Wiltshire Council Planning Consultation Response

URBAN DESIGN

Application No: PL/2026/00135

Proposal: Approval of reserved matters for the demolition of existing structures and construction of 90 homes, with areas of open space, a play area, sustainable drainage infrastructure, internal roads, paths and parking areas, landscaping and associated works, plant and infrastructure and discharge of conditions 7 (boundary with Abberd Farm), 8 (Surface Water), 9 (Surface Water), 14 (Construction Ecological Management Plan), 15 (Landscape Ecological Management Plan), 16 (Lighting), 17 (Wildlife Features) and 18 (Noise Assessment) of outline planning permission PL/2022/07893

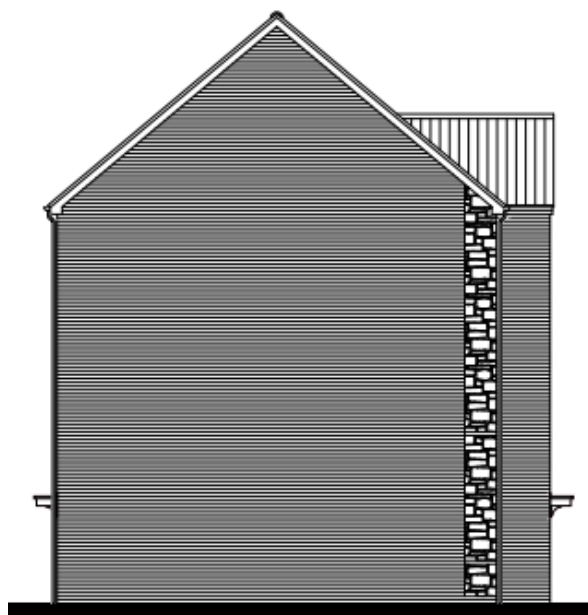
- 6) WDG Expectation 9.2.2 states that the minimum garden area for all houses should be at least equivalent to the building footprint. It appears that the garden areas for Plots 2, 30 and 59 may fall below this requirement. Please provide a plan demonstrating compliance with Expectation 9.2.2, indicating which plots meet the requirement and which do not, to enable a full and accurate assessment.

✓ Reason - The matter has been resolved. All rear gardens now appear to be the minimum size or larger.

Plot 18 Oakham (stair well window only)

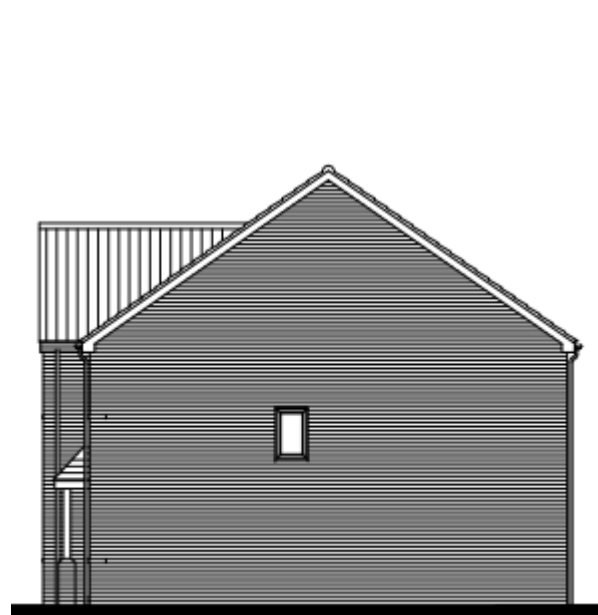
- 7) Street/street corner return elevations and street/open space corner return elevations have largely attractively placed and proportioned windows utilising house types that are consciously designed for this purpose, but there are the following exceptions below in locations. These would represent 'what red looks like' BfHL (pp 54-55) rather than the preferred 'what green looks like' (pp 52-53), and WDG expectation 4.2.8. *'Where buildings are on a corner both public elevations should be designed as 'frontages' and have windows from habitable rooms in them'*

✓ Reason – Plot 18 no longer an Oakham
